UNITED STATES PATENT AND TRADEMARK OFFICE

APPLICATION NO.	FILING DATE	FIRST NAMED INVENTOR	ATTORNEY DOCKET NO.	CONFIRMATION NO.
10/551,624	06/26/2006	Stephane Moreau	17258/002001	5504

Office Action Summary	Application No. 10/551,624	Applicant(s) MOREAU ET AL.	
	Examiner ALEXANDER B. COMLEY	Art Unit 3746

DETAILED ACTION

FIG. 3

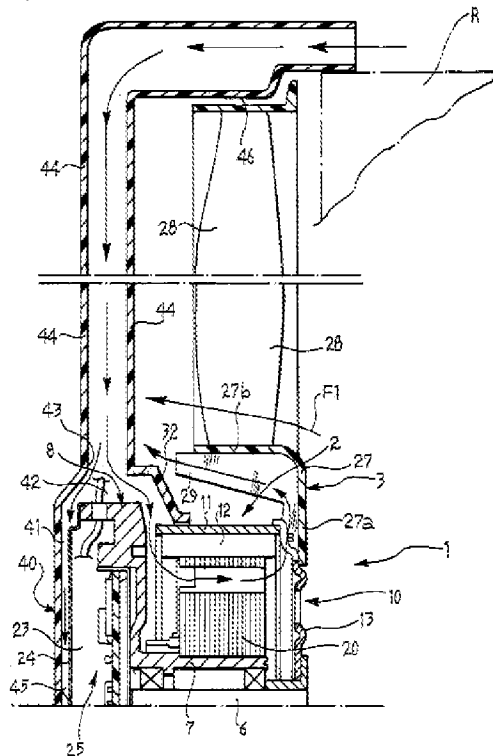
In regards to Independent **Claim 1**, and with particular reference to Figure 3 shown immediately above, Avidano discloses:

(1) A ventilation device (1) comprising a fan (3) capable of being driven rotationally by an open electric motor (2) which is firmly attached to a support (40, 44) intended for fixing said ventilation device, the fan consisting of a plurality of blades (28) which are distributed regularly around a bowl (27) inside which there are arranged internal ribs (29) capable of ventilating said open electric motor, characterized in that the support comprises a central part (32) which is connected in a substantially sealed manner to at least one peripheral portion (11) of the open electric motor, the central part of the support comprising a hole (41,

As shown in Figure 3 above, Avidano et al. discloses an electric motor-driven fan unit for use in motor vehicles. Avidano's fan is designed with a hub and airflow structure that allows the fan's internal blades to cool the motor. In particular, Avidano states "A motor-driven fan includes an electric motor including a rotor and a stator in which the rotor includes an essentially cup-shaped cap which extends at least partly around the stator and has a plurality of lateral exit openings adjacent the bottom wall, and an impeller or fan including a hollow hub from which extends a plurality of main outer fan blades. This hub has a front wall fixed to the back wall of the cap of the rotor and a lateral skirt which surrounds the lateral wall of the cap in a radially spaced relationship. The hub is further provided with inner ventilation blades acting in operation to generate a cooling air stream which passes through the motor." (Abstract) Moreover, Avidano specifically describes the hub structure of Applicant's claimed invention by stating "The fan or rotor 3 of the motor-driven fan comprises a hollow hub 27 (FIG. 1) from which extends a plurality of main outer fan blades 28. The hub 27 has a front wall 27a fixed to the radial projections 15 of the disc element 13 of the cap 10, by means of rivets 29 or the like (FIG. 1). The hub 27 of the fan 3 further has a lateral, essentially cylindrical, skirt 27b which surrounds the side wall or ring 11 of the cap 10 in a radially spaced relation thereto. As is seen in FIG. 1, the hub 27 of the fan 3 is further provided, in the space 30 defined between the ring 11 of the cap 10 and the skirt 27b of the hub of

Clearly from this disclosure, support 32 supports the motor within the opening (41, 42) and is substantially sealed to the motor since it acts to precisely control the airflow paths to prevent mixing thereof, as well as prevent ingress of harmful substances to the motor.

4. In regards to dependent **Claims 2-5 & 15**, the annular separator element 32 forms an opening (41, 42) (i.e. hole) that surrounds and holds the outer periphery of the motor element 2. Moreover, it can be seen in Figure 3 that the inner edge of separator element 32 cooperates with the annular wall of the motor in a continuous, contiguous fashion, while the cover 24 cooperates with the rear portion of the motor. In particular, Avidano states "The portion of the rear body 40 facing the cover 24 of the stator is conveniently provided with at least one projection 45 in contact with this cover for the purpose of reducing or cancelling the effects of vibration." (Column 3, Lines 52-55) In regards to dependent **Claims 6-10**, it can be seen in Figure 3 that a blind hole, which surrounds and holds the rear portion of the electric motor, is formed between the annular separator element 32 and the cover 24. This opening (or hole) is attached to the rear part of the motor by tight fitting, and forms a plate around the rear portion of the motor. Regarding dependent **Claims 11-14**, the annular separator element 32 forms a surface opposite the bottom of the hub (i.e. bowl) that directs airflow from the inside of the hub to the outside of the hub (See Figure 3). Moreover, the separator has a

concave shape (a quarter of a circle) that is flat, extends discontinuously (as its contour changes), and extends substantially linearly at a portion thereof. Finally, in regards to dependent **Claims 16-18**, Avidano's fan contains a peripheral part 44 that forms a frame with the central part. Moreover, Avidano's fan is for use in both an engine cooling device, as well as a motor vehicle. In particular, Avidano states "The rear body 40 may advantageously be formed integrally with a support structure to which the motor-driven fan 1 is fixed and defining a passage 46 for conveying the air stream caused in operation by the main blades 28 of the fan. In this case the aspiration duct 44 can be formed at least partly in a spoke of this support and conveying structure. In the case of a motor-driven fan associated with a radiator R the inlet aperture of the aspiration duct 44 is conveniently situated outside the boundary of this radiator R." (Column 3, Lines 59-67)

6. In regards to Applicant's arguments regarding the supports (40, 44) not supporting the motor, the Examiner must respectfully disagree. As shown in Figure 3 above, the entire support structure is composed of rear body 40, aspiration duct 44, and central ring 32 (which forms hole 41, 42). These structures are formed as a single, integral piece, which is indicated by the crosshatching in the figure. With reference to

Figure 4, Avidano shows that rear body 40 is fixed (i.e. supports) the stator body 8, which is a primary structure of the motor 2. Avidano discloses this supporting function of the body 40 by stating "In the embodiment of FIG. 3 a rear body 40 is fixed to the stator body 8 on the side opposite the fan 3, which extends in facing and spaced relationship with respect to the cover 24 and which surrounds the periphery of the stator body 8 lying close the annular separator element 32." (Col. 3, Lines 41-46) Avidano goes on to say "The rear body 40 may advantageously be formed integrally with a support structure to which the motor-driven fan 1 is fixed and defining a passage 46 for conveying the air stream caused in operation by the main blades 28 of the fan. In this case the aspiration duct 44 can be formed at least partly in a spoke of this support and conveying structure. In the case of a motor-driven fan associated with a radiator R the inlet aperture of the aspiration duct 44 is conveniently situated outside the boundary of this radiator R." (Col. 3, Lines 59-67) It can easily be seen in Figure 4 that the motor is supported by the distal end of the support ring 32 such that motor is held at one end by ring 32 and by radiator R at its opposite end. The Examiner must assert that Figure 3 and Avidano's disclosure makes it clear that the supporting body (40, 44, 32) provides a supporting function to the motor, and has ring 32 (which forms motor hole 41, 42) formed integrally at the center thereof.
